MONTGOMERY COUNTY PLANNING DEPARTMENT
 THE MARYLAND-NATIONAL CAPITAL PARK AND PLANNING COMMISSION

MEMORANDUM

PROJECT NAME: City Place
CASE #: 91987001A, 11987190A, & 81988046B
REVIEW BASIS: Chapter 50, Montgomery County Subdivision Regulations
 Sections 59-D-3.7 & 59-D-2.6, Montgomery County Zoning Ordinance

RECOMMENDATION: Approval of Project, Preliminary, and Site Plans with conditions.

Public use space plan.

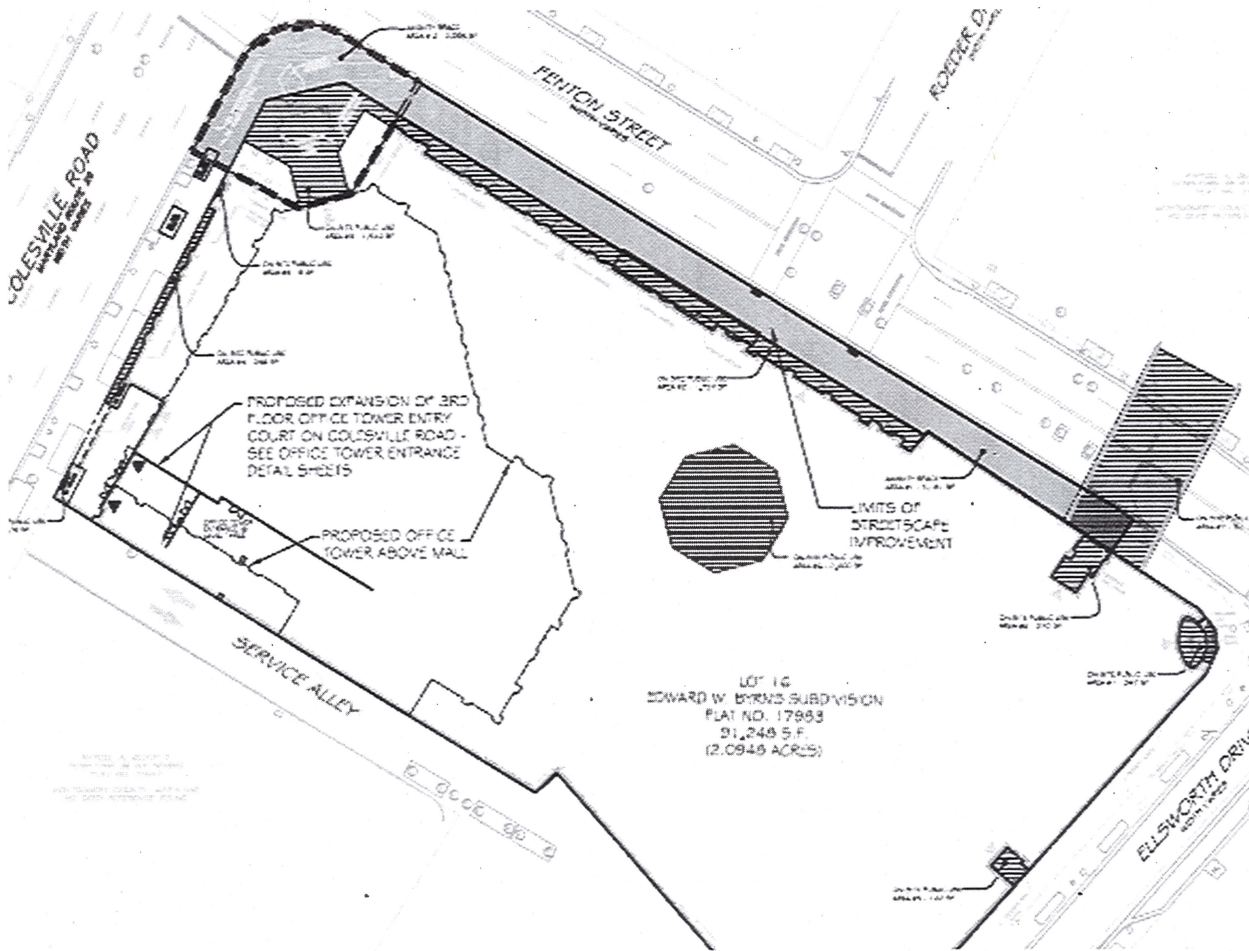
There are two clarifications to be made. First, the Applicant is requesting credit for their improvements of Kughn Park during the construction of Phase I, which we have agreed with despite their having received compensation for the annexation of that site. Also, the pedestrian bridge, although constructed by the Applicant during Phase I, is not within the property line boundaries of the subject site but is included in the “on-site” calculations as it was in the previous approvals. Second, the total off-site Public Amenity Space will increase when the Applicant renovates the entrance at the corner of Fenton Street and Colésville Road to approximately 7,000 square feet, which will bring the total public use space calculation to 27,600 square feet. This is still only about 30% of the revised net lot area of 91,248 square feet (due to alterations in dedications).

A typical optional method project in the Silver Spring CBD provides between 40% and 60% of its net lot area as Public Use and Amenity Space (20% on-site and the balance off-site). This range takes into account the range of other amenities provided and how much the respective applicants have “maximized” their density allowance. The proposed development is requesting the full optional-method FAR and the maximum height limit (within eight feet). As the Memorandum from Community Based Planning Staff, dated July 6, 2007 (Appendix D) has elucidated, the approvals for this project expired when the office tower was not built within the approved conditional timeline. Thus, we believe the proposed amendment is more similar to a

As such, we have requested the renovation of the corner entrance at Fenton Street and Colesville Road, which the Applicant has agreed to. We also believe the original condition to provide day care should be retained in addition to the proposed public-use space renovations and additions of art and art programs with the modification proposed in the Project Plan Conditions. That modification allows the Applicant to contribute \$150,000 to a park acquisition and improvement fund rather than aiding in the provision of day care within the CBD. This amount is based on two approximations. The first is that the original capital contribution of \$84,100 and the \$10,000 initial scholarship payment from the original 1989 condition is equal to approximately \$154,000 as adjusted for inflation. The second is that the alternative provided in the original condition to build the streetscape improvements on the opposite side of Fenton Street would have been about 7,500 square feet of paving, lighting, and landscaping. The average cost of providing the standard Silver Spring Streetscape (limited in this case to paving, lighting, and landscaping) is between \$15 and \$25 per square foot. Using the average cost to calculate the original area of required improvements yields \$150,000.

SHEET NO. P-1

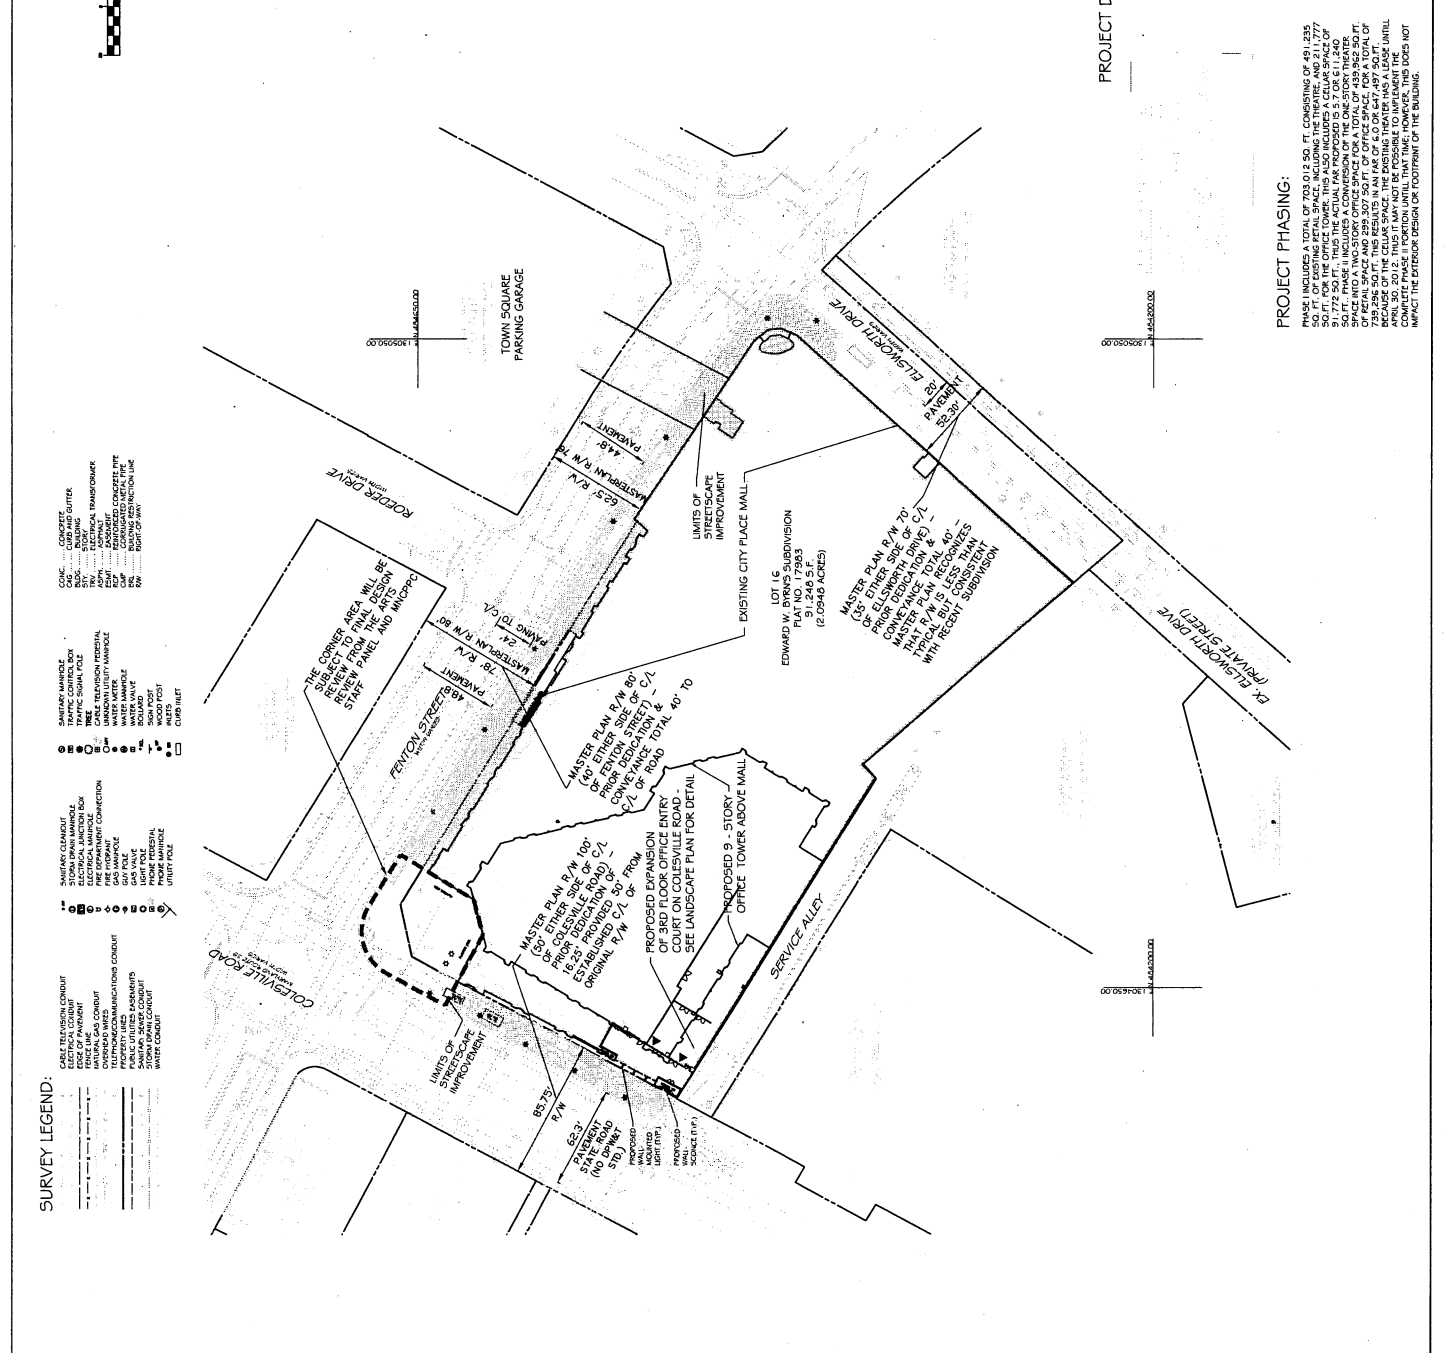
We have completed our review of the preliminary plan dated 08/14/06. This plan was reviewed by the Development Review Committee at its meeting on 03/12/07. We recommend approval of the plan subject to the following comments:

1. Show/label all existing planimetric and topographic details specifically driveways adjacent, opposite and on the site, sidewalks and/or bikeways on the preliminary plan.

2. Necessary dedication for Colesville Road, Fenton Street and Ellsworth Drive in accordance with the Master Plan.
3. Improve Fenton Street to arterial and Ellsworth Drive to commercial roadway standards.

4. Grant necessary slope and drainage easements. Slope easements are to be determined by study or set at the building restriction line.
5. The applicant's engineer has informed us that there will be no change to existing access points or impervious areas as part of this amendment to the preliminary plan. DPWT has determined that as long as above statement is applicable, no sight distance analysis or storm drain study is required.
